Department of Energy
Richland Operations Office
P.O. Box 550
Richland, Washington 99352

WM Project WM-10

INTERPRETATION OF RRL-2 DRILLING RESULTS (SCR-19)

BOREHOLE GEOPHYSICAL LOGS
BOREHOLE: RRL-2

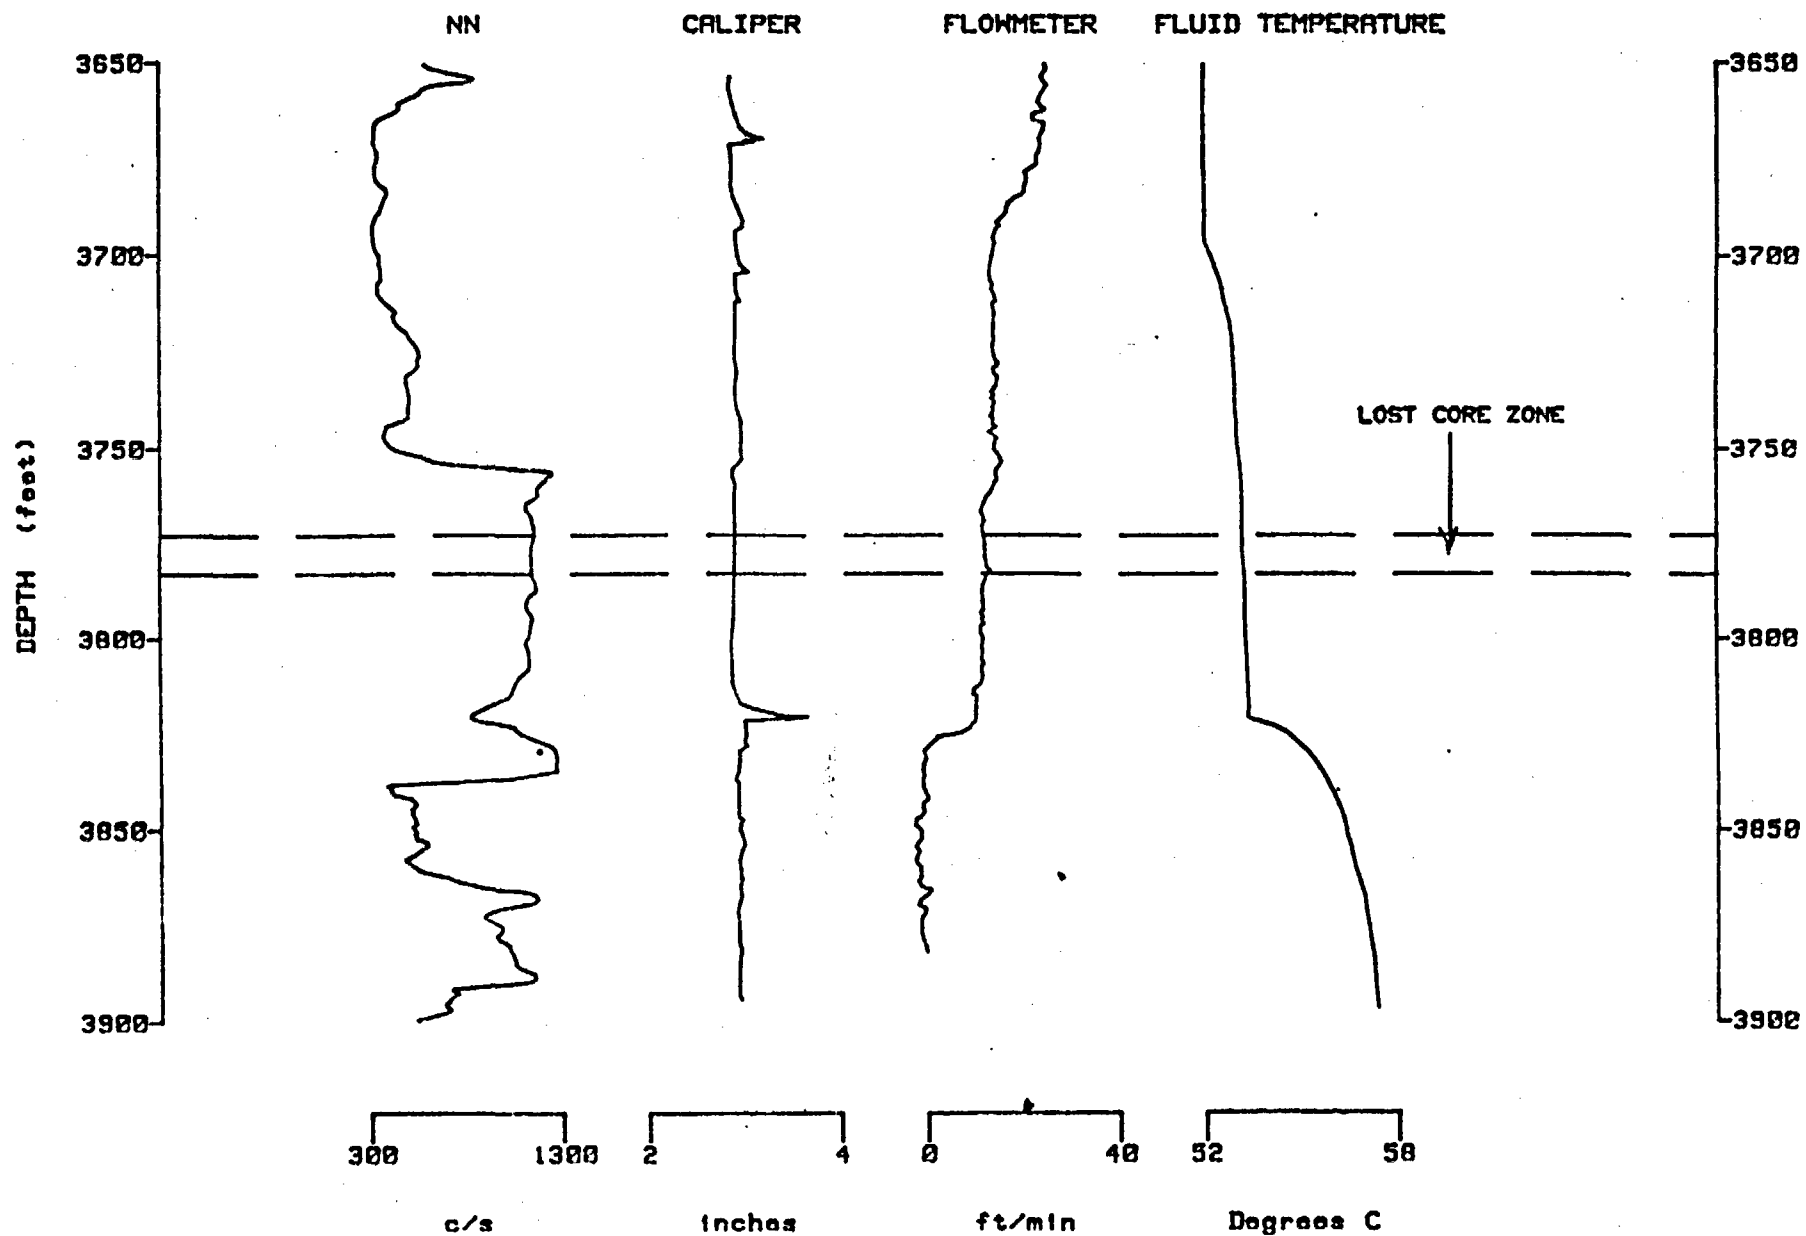
1A. Explain the basis for assuming the 3,773'-3,783' interval of RRL-2 is dense basalt (Reference RHO-BWI-TI-113). What field data and records support this assumption? Is this based solely on hydrological testing and the neutron/neutron log? If so, how much confidence can be placed on this assumption?

The interpretation that the 3,773' to 3,783' interval in borehole RRL-2 is dense basalt is based upon two suites of borehole geophysical logs, a suite of hydrological tests, in situ stress measurements and "Shift Report of Operations".

The borehole geophysical logs performed by Battelle - Pacific Northwest Laboratory (PNL) (attached), across the 3,773' to 3,783' interval, indicate the rock mass to be dense and relatively impermeable. The other suite of borehole geophysical logs conducted by Birdwell indicate identical responses to that of PNL. The neutron log response is typical of a dense interior. The caliper logs do not indicate a washout or out-of-gauge hole. The flow-meter, which was conducted during air lift pumping and fluid temperature logs, do not indicate any fluid passing in or out of the 3,773' to 3,783' interval.

As all data supports the rock in the zone 3,773'-3,783' being dense basalt interior, we have a high degree of confidence that this is the case.
